Carmichael Coal Project Response to IESC Advice

Please find below our response to the key conclusions included in the IESC Advice to decision maker on coal mining project relating to the Carmichael Coal Project dated 12 December 2013.

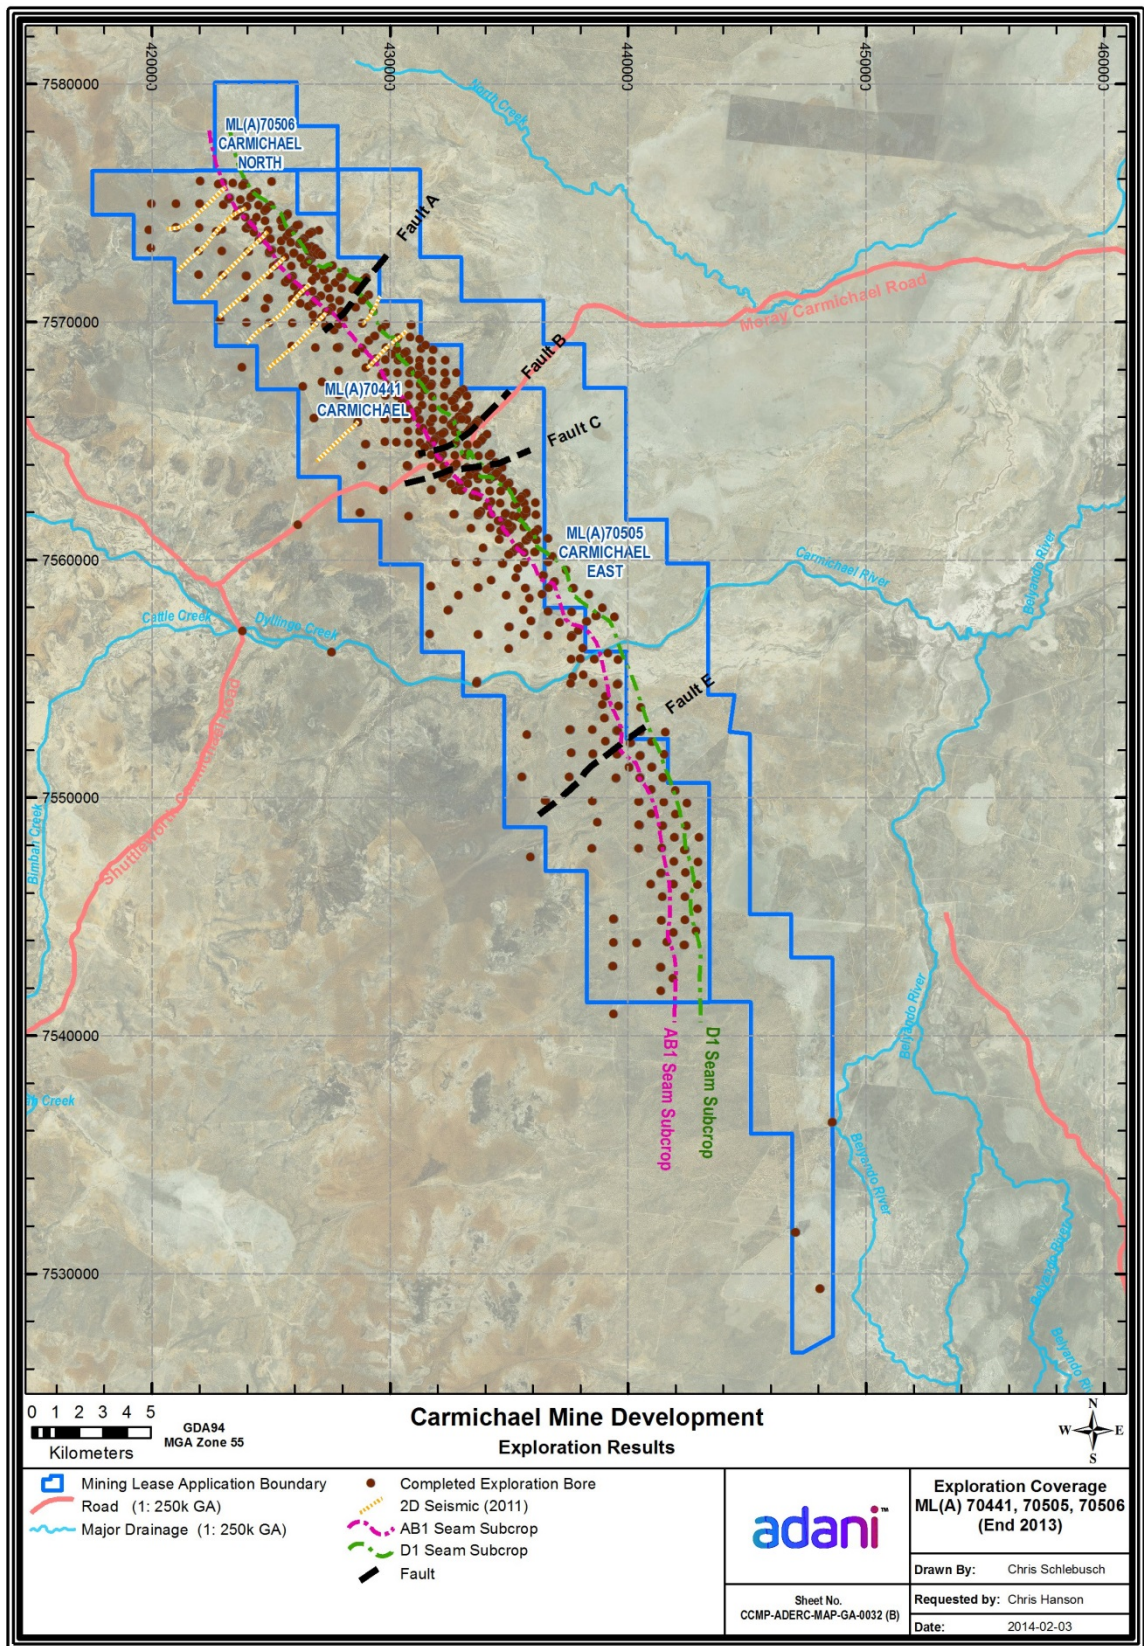
Regional Faults: The conceptual model would benefit from an assessment of regional faults. The proponent's groundwater model does not take into consideration the influence of faulting within the Rewan Formation. The Committee notes that faults have been identified on the eastern boundary of the Galilee Basin within the Rewan Formation in other project proposals, but their potential role on groundwater flow processes has not been considered in this project.

Some studies (including the Queensland Carbon Geostorage Initiative Atlas, 2009) suggest the presence of a number of faults close to the boundary between the Galilee Basin and the Drummond Basin to the east (i.e. to the north and east of the proposed mining area). This information was considered in overall geological assessments for the Carmichael Coal Project, and by independent geologists acting as Competent Persons under JORC 2012, who have undertaken JORC Resource modelling assessments. JORC assessments have been undertaken by Xenith Consulting (Turner, 2013), and also more recently by ROM Resources (Mark Biggs, 2014), who are currently preparing an updated resource assessment (see Attachment 5). Following overall assessment of the publically available regional geology reports and maps, together with JORC resource modelling by these recognised independent geologists, it is concluded that there is a general absence of any significant faults in the area. This conclusion is based

on structural geological interpretation to a JORC 2012 compliant standard, which is underpinned by a significant density of drilling and seam interpretation throughout the area as shown in Figure 1.

High quality 2D seismic which has been interpreted along the lines shown in Figure 1, demonstrates no significant regional fault structures intersecting these lines.

The JORC Coal Resources Estimate for the project (Turner, 2013), suggests the presence of only four minor faults in the coal strata, with vertical throws between 20 m and 40 m, trending in a general east - west direction (see Figure 1). This interpretation has recently been substantiated by Mark Biggs, ROM resources (see Attachment 5) based on additional drilling data provided by Adani from the 2013 drilling program.

Figure 1

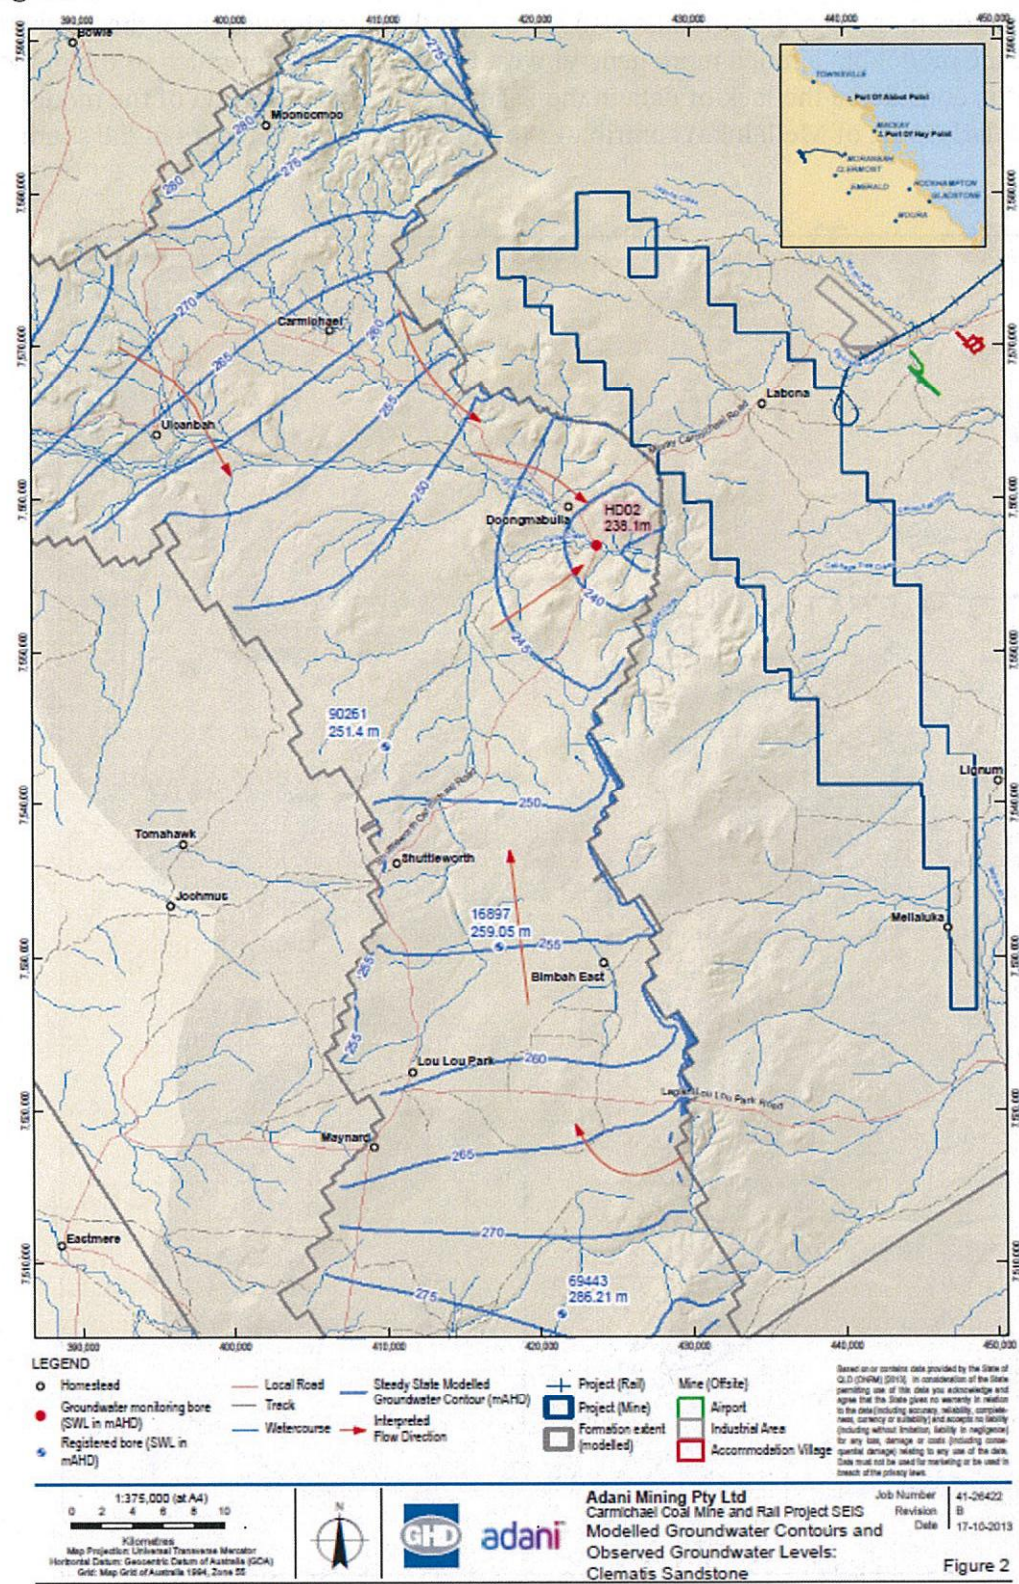
There are important data gaps, especially in the deeper groundwater systems, most notably hydraulic head information, which bring into question the conclusions being drawn about groundwater flow directions. The groundwater flow interpretation contained within the draft SEIS appears to be based primarily on shallow groundwater monitoring. This interpretation is not considered to be consistent with expected groundwater flow for deeper formations, given regional geology and accepted regional groundwater flow directions within the Great Artesian Basin (GAB). There is insufficient data provided in the draft SEIS to substantiate the proponent's groundwater flow conceptualisation.

The south to north gradient is shown in Figure 1 (Figure 2 from the Adani SEIS Appendix K6 groundwater addendum). Data from three landholder bores and monitoring bore HD02 are used by GHD to demonstrate a south to north gradient and west to east gradient towards the Doongmabulla springs complex. Note that HD02 is located adjacent the most easterly spring in the complex.

Hence we have a groundwater gradient lowering from the south to the north and from the west to the east, resulting in discharge to the Doongmabulla Springs and the Carmichael River. The data supports the GHD conceptualisation.

Figure 1 Conceptual Groundwater Model – South Galilee Coal Project (RPS Aquaterra, 2012)

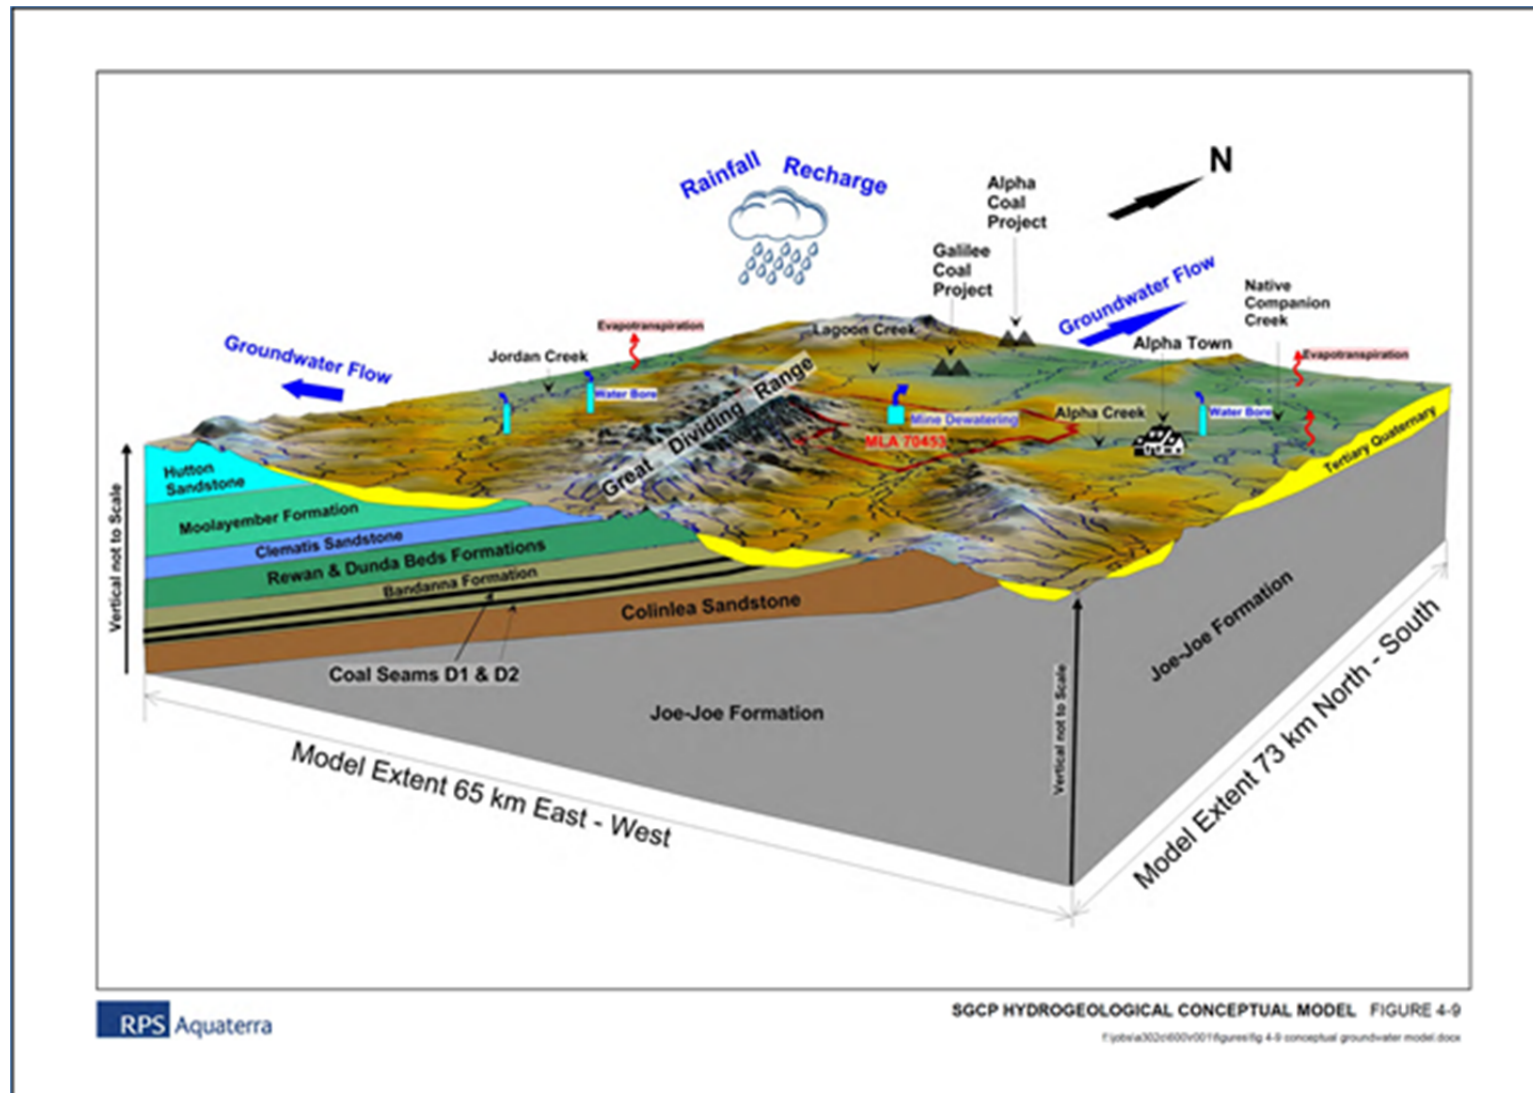
The IESC in their "Advice to decision maker on coal mining project" document (dated 12 December 2013) included the comment that the independent peer review of the groundwater model undertaken by URS also notes that the model flow direction is at odds, and is not consistent, with the regional flow direction and geology.

The flow within the Permian units along the eastern edge of the Galilee Basin (east of the Great Dividing Range), perpendicular to the dip of the strata (strata dips east to west) is recognised in Kevin's Corner, Alpha, Galilee, and South Galilee coal projects, as conceptualised in the South Galilee Coal Project (RPS Aquaterra, 2012), where flow in the Permian is to the north along the eastern edge of the Galilee Basin (Figure 1). This conceptualisation is validated in DNRM report, which considers flow within the Colinslea Sandstone across the eastern edge of the Galilee Basin.

The Permian coal bearing units are confined on three sides, above by the Rewan Group and Tertiary saprolite, below by the Early Permian sediments and to the west where the units pinch-out. The potentiometric pressures within these Permian units have equalised across the basin, resulting in the potentiometric pressures recorded in monitoring bores across the CPP area. The groundwater resources are recharged in the topographic highs (to the southwest and northwest) resulting in groundwater flow in the near horizontal (shallow dip on the eastern side of the Great Dividing Range) and more permeable (coal) units.
